Attachment D-2

Public Comment Letters

RE: SC# 2016121064 Los Angeles Union Station Forecourt & Esplanade Improvements Project, EIR Addendum #2

1. Adjustments to Shade Cover:

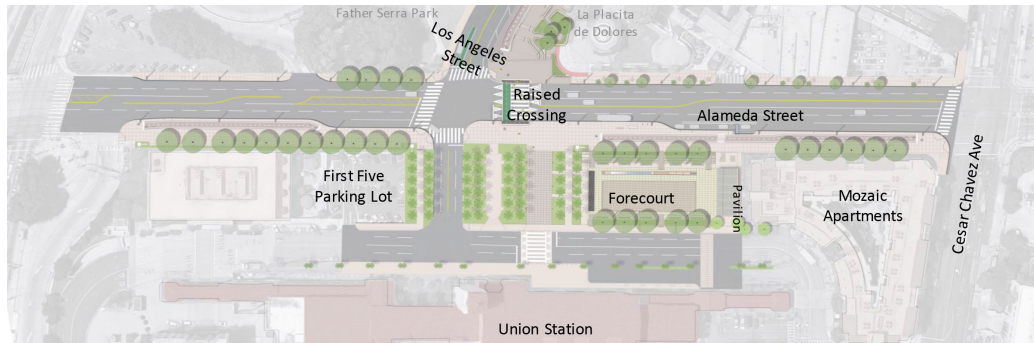
The 2015 Union Station Master Plan (“Transforming Union Station”) presented a vision for the improved pedestrian experience in accessing Union Station from Alameda Street. This plan called for the installation of new double-rows of mature sidewalk trees providing shade cover from midday sun. The plan showed 76 mature sidewalk trees located in double-rows to enhance the pedestrian experience, aesthetics, and usability of these sidewalks on hot days.

With adjustments to the proposed roadway configuration of Alameda Street, Metro is now proposing to eliminate 50 of the originally planned 76 Alameda sycamore or similar shade trees (a reduction of 28 from the 54 trees on Alameda referenced in the adopted 2018 FEIR). Additionally, the revised plan shows 17 more trees relocated away from the center of the sidewalk to the edge of the Metro property line. These combined changes in reduction and relocation of shade trees result in a significant reduction in the amount of shade cover provided to pedestrians and bicyclists in accessing Union Station.

Addendum #2 Section 5.1.1 states, “These elements would not result in any impacts to any trees along Alameda Street that were not already accounted for in the Approved Project. Therefore, the Alameda Esplanade revisions would result in no impacts to aesthetics.” This statement is obviously false in review of Metro’s design presentation, proposal to eliminate double-rows of trees, and provision of only 26 mature shade trees on Alameda in place of 76 as envisioned. Metro must study the aesthetic impact of this large reduction in mature sidewalk trees, study the resulting

changes in temperature along non-shaded areas during heat waves, and provide alternatives to improve aesthetics and sidewalk temperatures for non-vehicular users.

Source: *Connect US Action Plan*, 10/5/2015

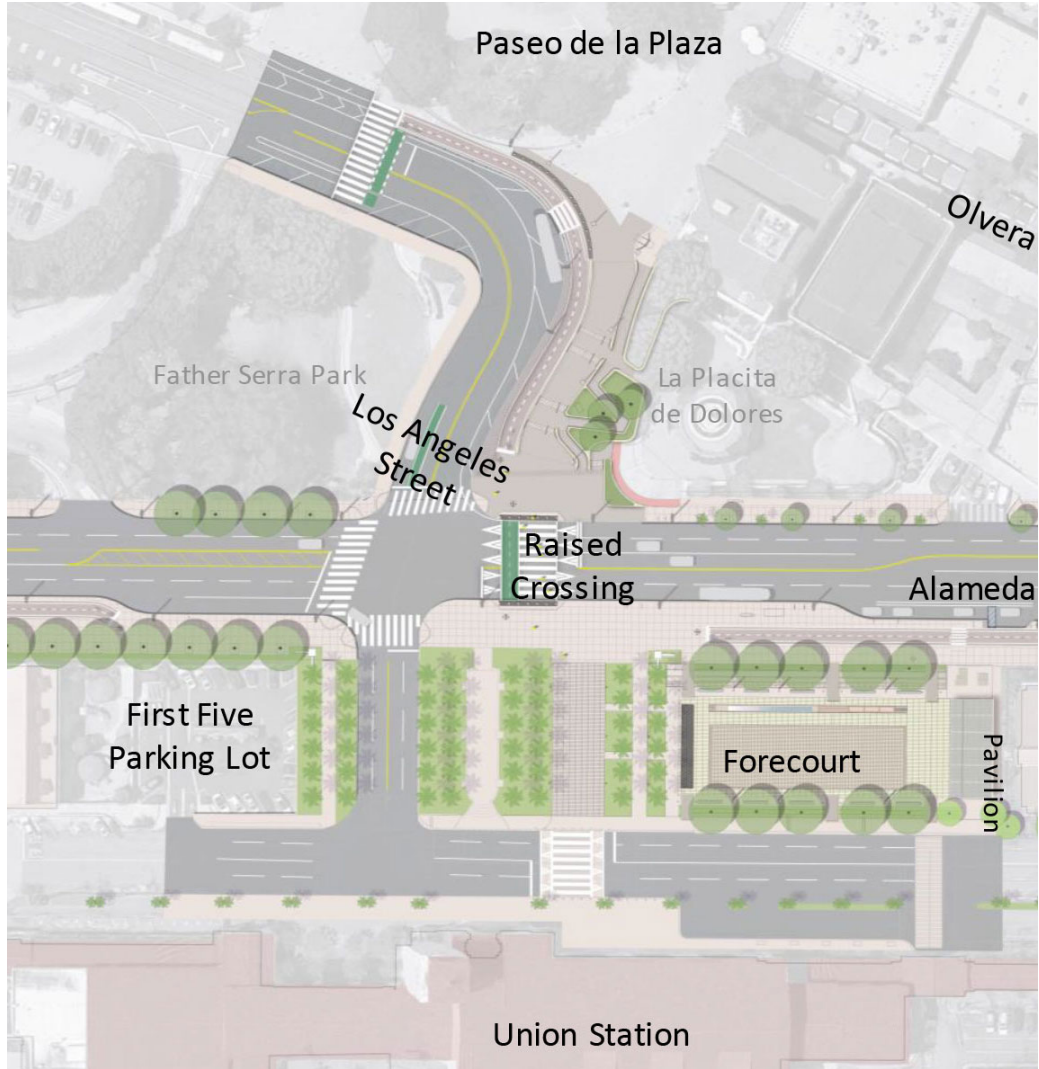
Providing a direct pedestrian connection between Union Station and El Pueblo was a primary goal documented in the Connect US Action Plan, which proposed a "direct walk-bike path between Union Station and the Plaza at El Pueblo." This proposal was incorporated into the Los Angeles Union Station Forecourt & Alameda Esplanade project through its objectives at providing direct pedestrian and visual connections between Union Station and El Pueblo. El Pueblo is one of Los Angeles' most important cultural monuments, and one of few focused on the indigenous and Latinx heritage of Los Angeles.

Despite not being detailed in Addendum #2, Metro project staff has communicated that the proposed Los Angeles Crossing will be reduced from 50 feet in width to 37 feet in width based on feedback from LADOT. A review of this reduction in pedestrian area is not provided, but it is clear from the revised design plan presented in August 2020 that the result is a misalignment off the intended direct connection. This causes a meandering path of travel for pedestrians, negatively impacting the achievement of objectives concerning accessibility, quality of pedestrian experience, and project aesthetics. The presented plan with a reduced crossing shows that the ADA-accessible ramp does not align with the raised crossing. This non-alignment with the accessible route would treat people with disabilities as separate and secondary; it does not abide by the provisions of Federal ADA or California Accessibility Code.

No justification has been provided to merit this unnecessary reduction in quality of pedestrian access and in meeting project objectives for direct connection, but it presumably is being requested to increase vehicular capacity on Alameda Street. While vehicular capacity is not an objective of the project, a direct connection between Union Station and El Pueblo is. Metro should expand the width of the enhanced crossing to align with both the accessible route to El Pueblo and the entrance to Union Station.

5. Stormwater Runoff:

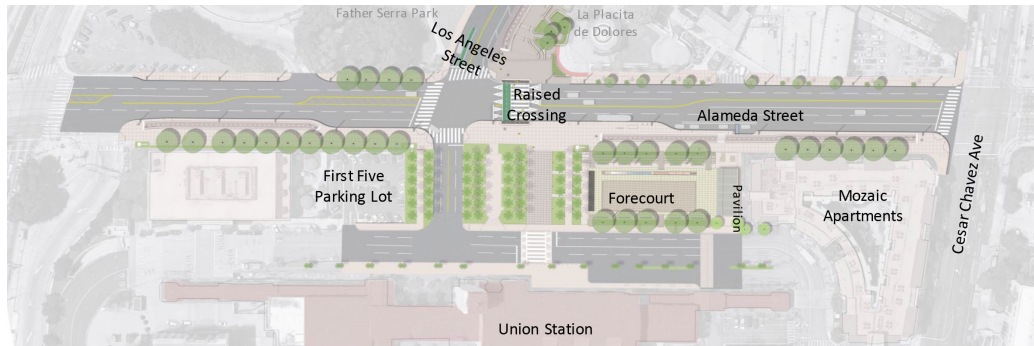
Addendum #2 Section 5.10 "Hydrology and Water Quality" provides no study to support its statement that a reduction in the number of mature trees and permeable surface area of landscaping has "No Impact" to stormwater runoff from the project scope adopted in the 2018 FEIR. If Metro seeks to eliminate 52% of mature sidewalk trees (28 of 54), Metro should provide a stormwater runoff study to justify that the

elimination of trees from the adopted FEIR has no impact to water systems and/or quantify the adjustment for public review.
